Product Change Notification

July, 2016

Changes to Bourns® Model 7100 Series Common Mode Chokes

Table 2

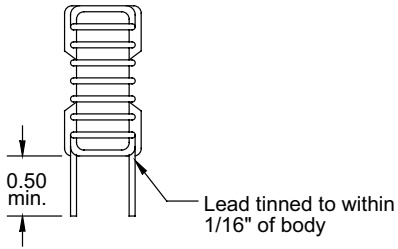
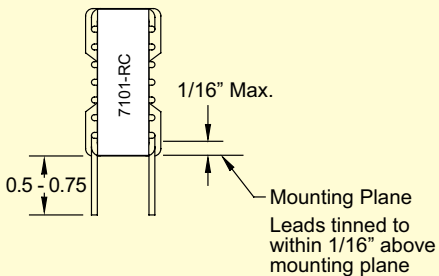
Model	Marking	
	Current	Revised
7100 Series	 Ink Stamped	 Inkjet Printed
	Terminal Lead Tinning / Lead Length (inches)	
	Current	Revised
